# Technical Service Bulletin

## SB-10057904-1731

SUBJECT:			No: TSB-15-13-001REV
<b>ENGINE STALL/PCV HOSE DISCONNECTION (LOW ENGINE SPEED, HIGH AMBIENT TEMPERATURE)</b>			DATE: July, 2015
			MODEL: 2014-15 Mirage
CIRCULATE TO:	<input type="checkbox"/> GENERAL MANAGER	<input type="checkbox"/> PARTS MANAGER	<input checked="" type="checkbox"/> TECHNICIAN
<input checked="" type="checkbox"/> SERVICE ADVISOR	<input checked="" type="checkbox"/> SERVICE MANAGER	<input checked="" type="checkbox"/> WARRANTY PROCESSOR	<input type="checkbox"/> SALES MANAGER

*This bulletin supercedes TSB-15-13-001, issued March, 2015, to add PCV hose disconnection details. Revisions are italicized and indicated by ◀.*

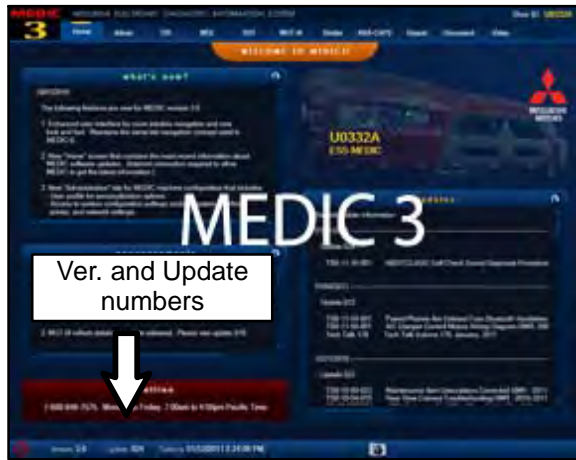
1. If the PCV hose is detached at either end (usually at intake manifold end), and is not damaged, reconnect it (red hose in illustration). Only replace the hose if it is damaged.
